REMARKS

IN THE DRAWINGS:

ANNOTATED MARKED-UP SHEET

FIG. 1 (Prior Art)

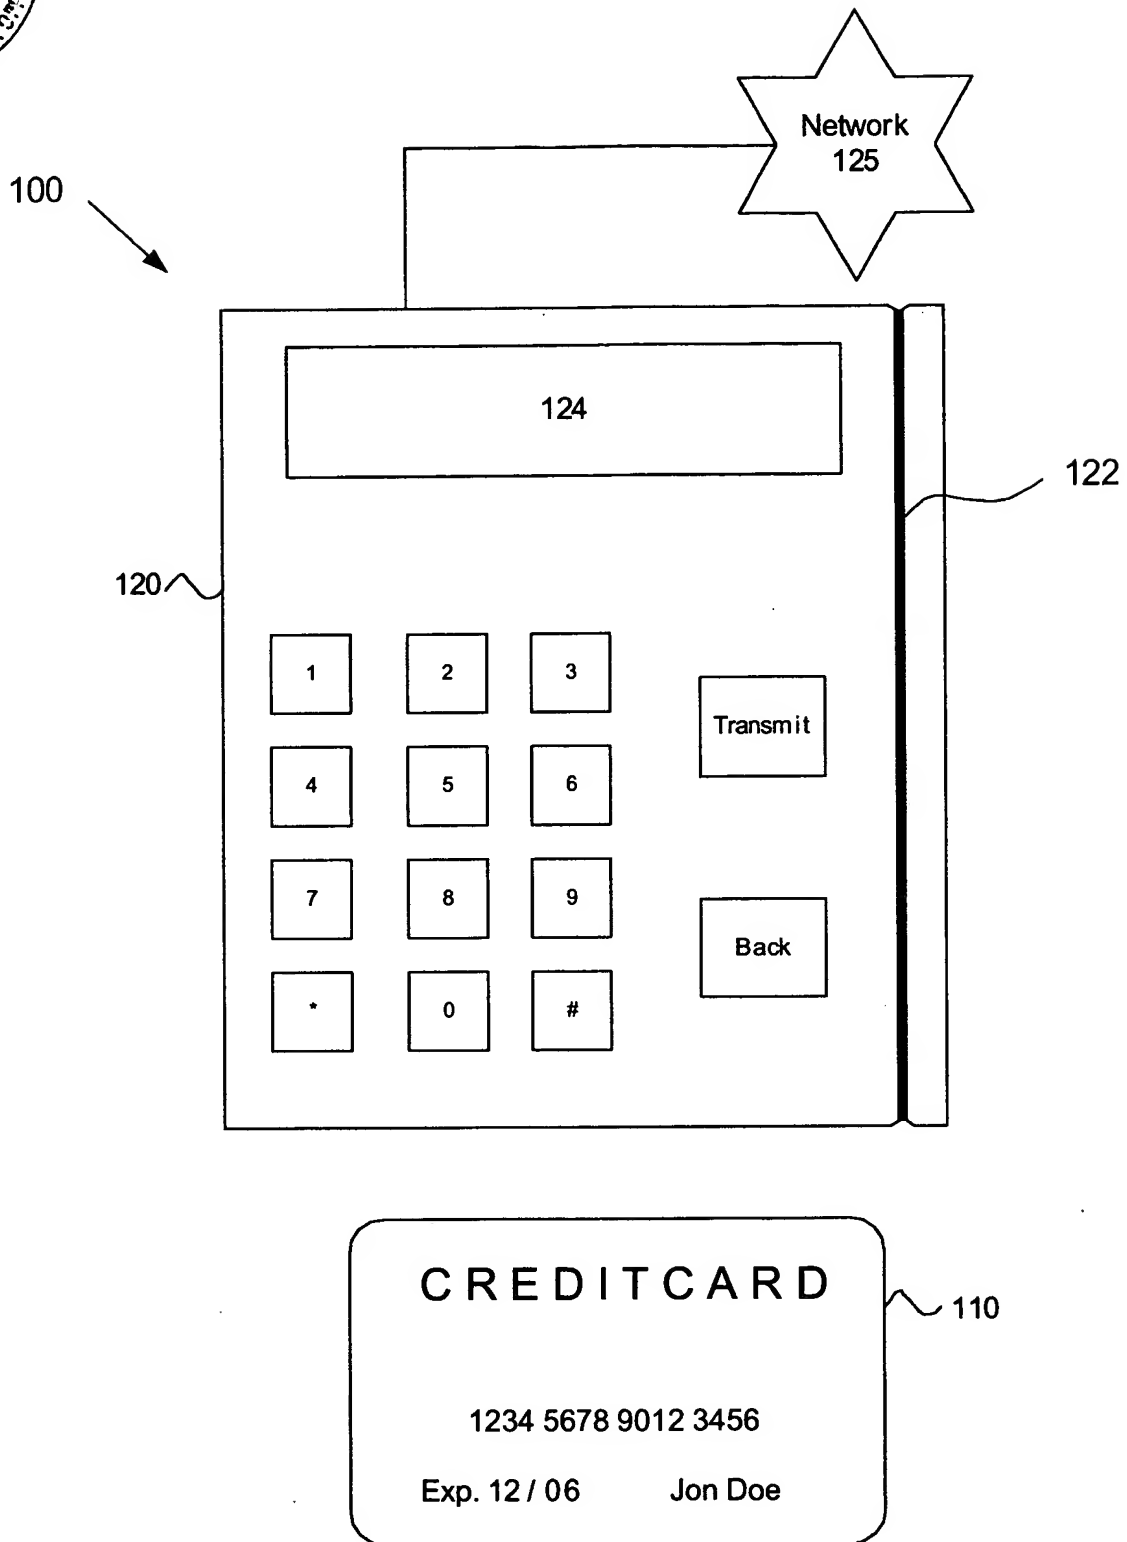
The Examiner states the drawings are objected to because referring to system 100, slot 122 and a card reader 230 as described in the specification, the numbers are not shown on the drawing. Applicants have made amendments to the drawings as required, included herein, to add the references numbers as instructed.

Figure 1 has been amended to add the number of the credit card processing system 100, and slot 122 integral to magnetic strip reader 120.

The Applicant proposes amendment of the drawings to correct errors noted subsequent to filing the application. The Applicant has submitted a proposed annotated marked-up drawing sheet and a replacement sheet.
